TECHNICAL SERVICES INFORMATION BULLETIN

TSIB 22-04 Rev B		July 18, 2023
TO:	All Operators	
TITLE:	Front Junction Box Cover Retrofit	
APPLICABILITY:	All MCI J4500, and J3500 coaches equipped with Power Distribution Panel (PDP) in front junction box

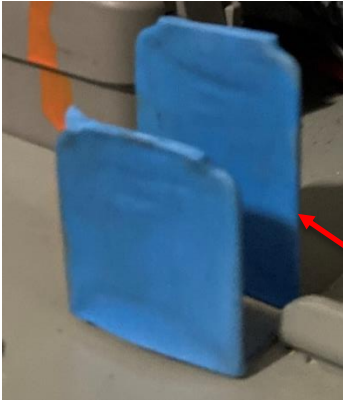
Remove and save the three screws securing the panel on top of the front junction box area.

Install heat shrink on the brackets

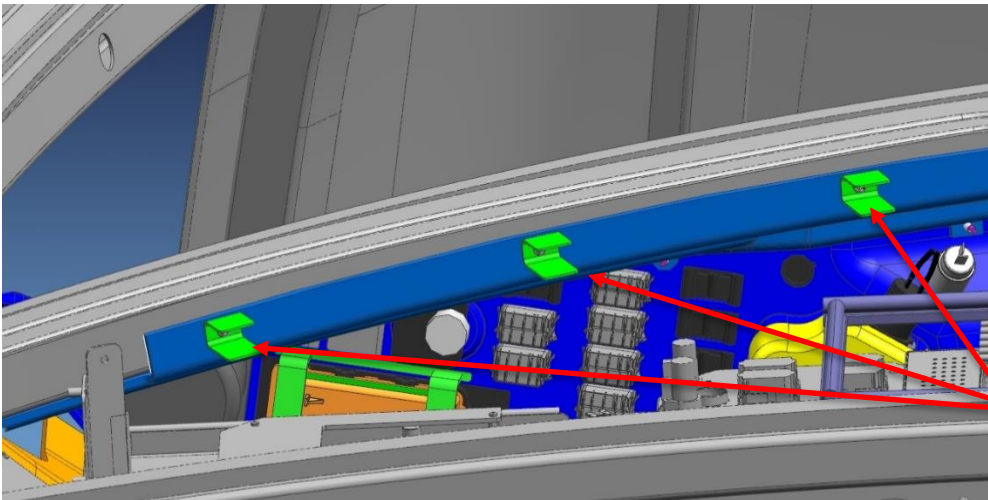
Install heat shrink, MCI P/N: 117202, on all six brackets, MCI P/N: 960199, as shown below.

Install brackets, 960199, using existing screws

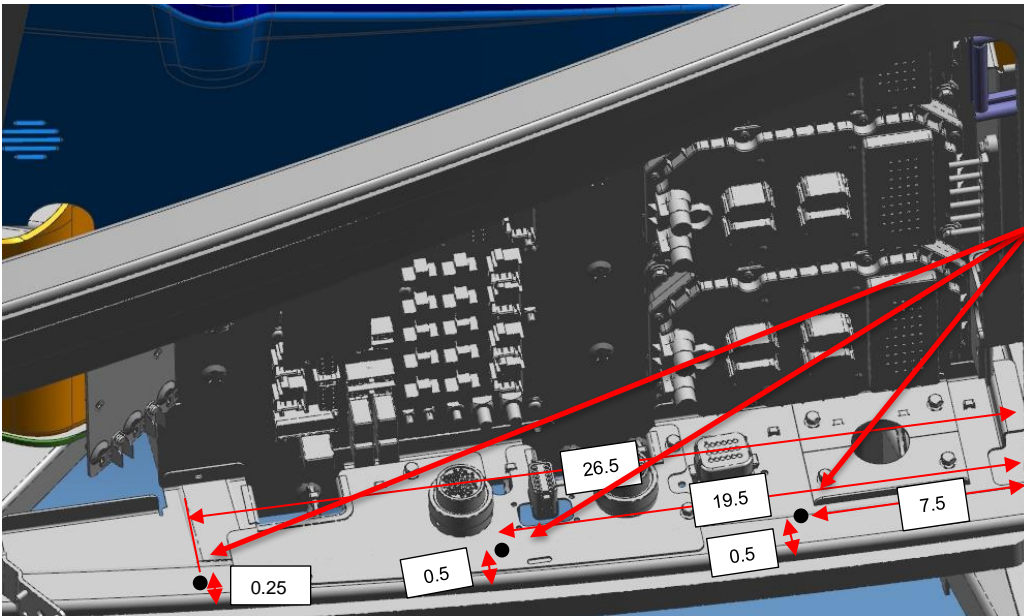
Install three brackets, MCI P/N: 960199, at the three holes using existing screws such that the longer face of the bracket is towards the back of the front junction box.

Install brackets, 960199, using 19-1-655 screws

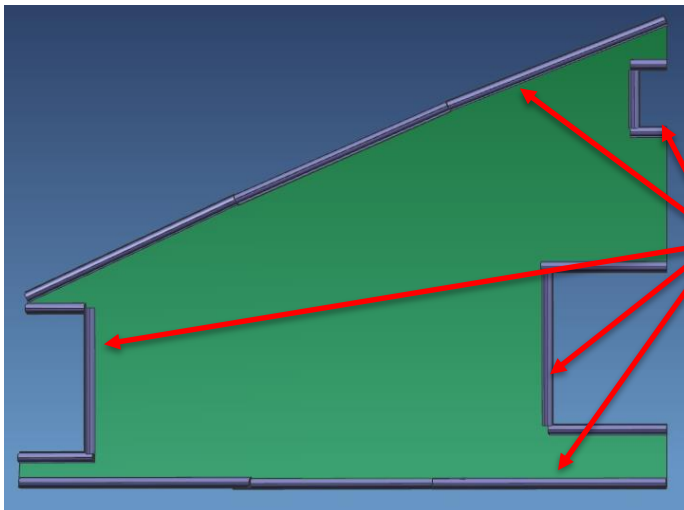
Mark three locations on the bottom of the front junction box panel at the dimensions shown below.

Install three brackets, MCI P/N: 960199, at the three marked locations using tapping screws, MCI P/N: 19-1-655, such that the taller face of the bracket is facing towards the front junction box.

Install trimlock w/ bulb seal around the panel

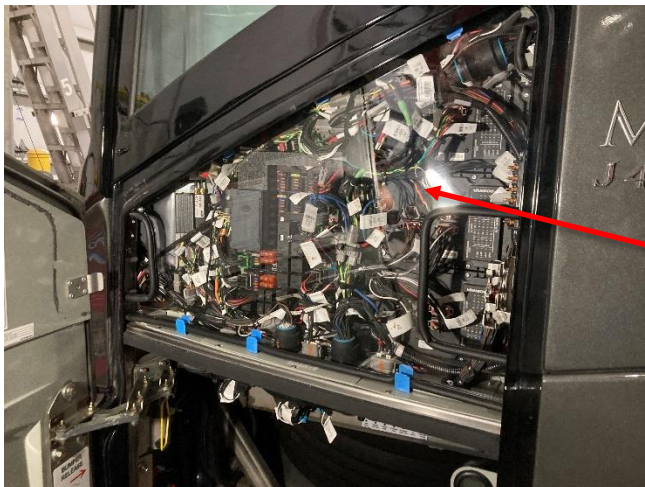
Install bulb seal, MCI P/N: 959998, around the top, bottom and cutout edges of the cover, MCI P/N: 959748.
